# HISTORIC AND DESIGN REVIEW COMMISSION

**HDRC CASE NO:** 2015-246  
**COMMON NAME:** HWY 90 W/W Military Dr.  
**ZONING:** UZROW  
**CITY COUNCIL DIST.:** 4  
**APPLICANT:** Alma Nunez/RVK  
**OWNER:** TXDOT ROW  
**TYPE OF WORK:** Lackland Corridor Streetscape Project  
**REQUEST:**

The applicant is requesting conceptual approval for the streetscape/site development plan of the Lackland Corridor Gateway.

Lackland Corridor Gateway  
Conceptual Site Development Submittal

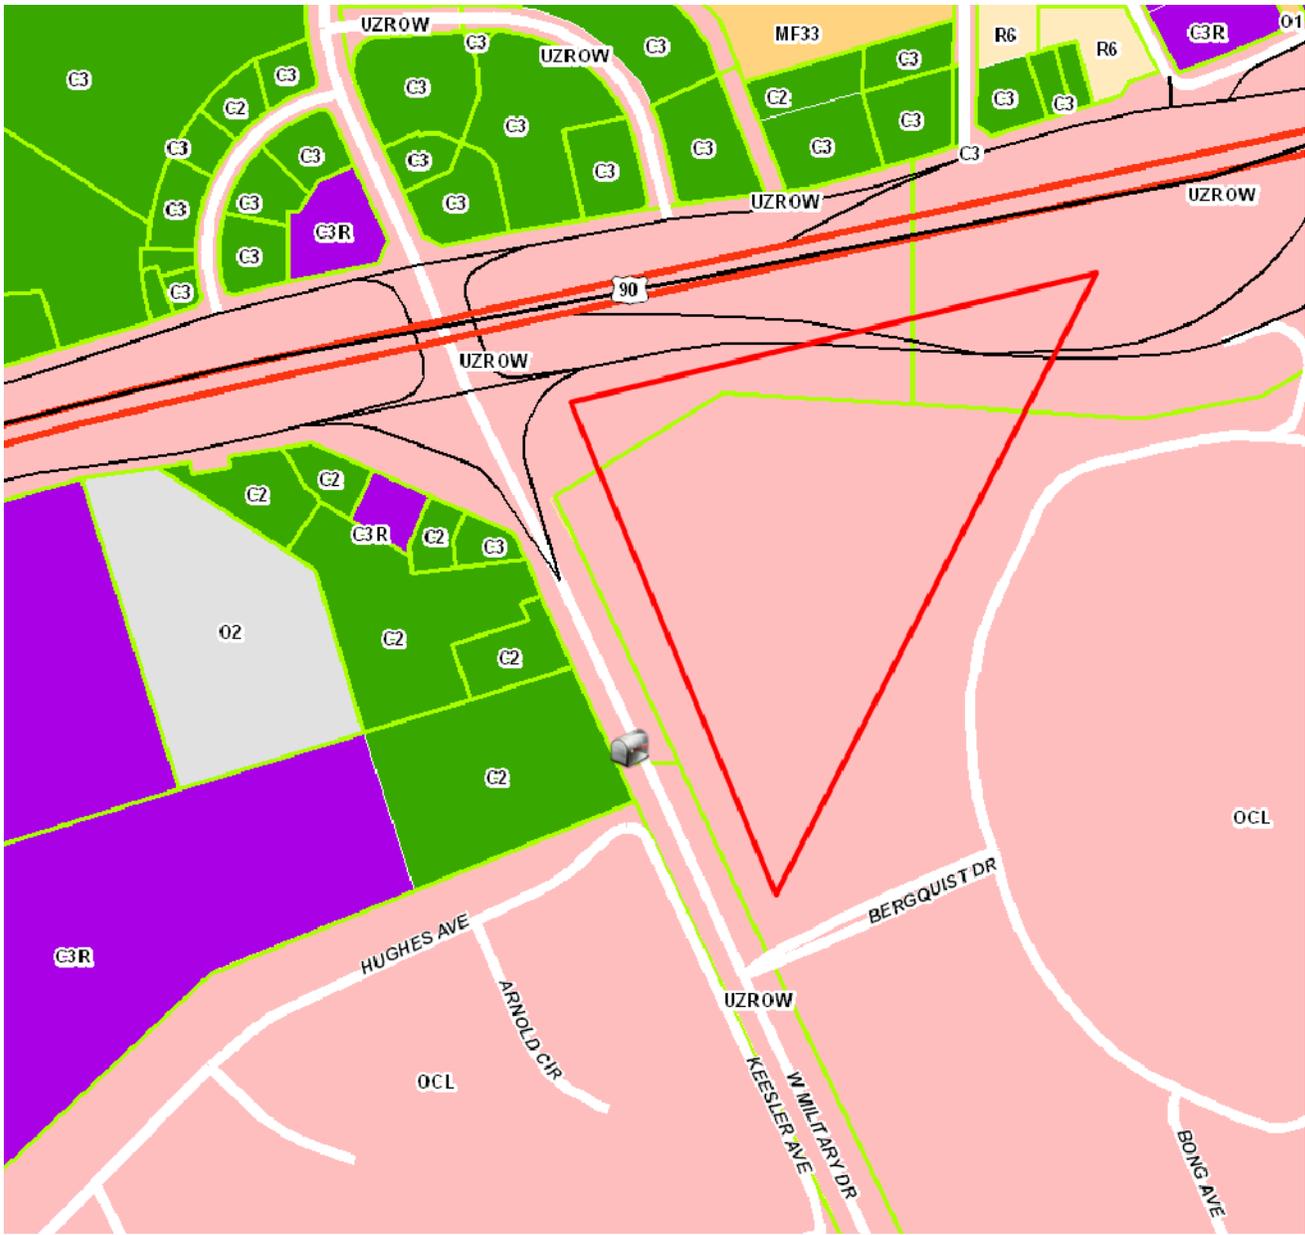
- a. The proposed site development plan is the first phase of the Lackland Corridor Streetscape conceptual master plan. This phase will begin at the intersection of SW Military and US 90 W, and will cover five acres.

- b. Consistent with the UDC Section 35-A.1-3, the site and setting of the proposed streetscape plan is compatible within the historically significant military context of the Lackland corridor.

- c. Consistent with the UDC Section 35-642.b.1 in terms of maintaining high design quality standards for public infrastructure, the proposed plan is appropriate to integrate vehicular traffic into an efficient and complete street that supports pedestrians, bicyclists, and users of public transit more accessible and inviting to users.

- d. Consistent with UDC Section 35-642(b), the proposed site improvements are of exceptional quality and respond to the character of the site and the time and place of which it will respond to.

Staff recommends conceptual approval based on items a through d.
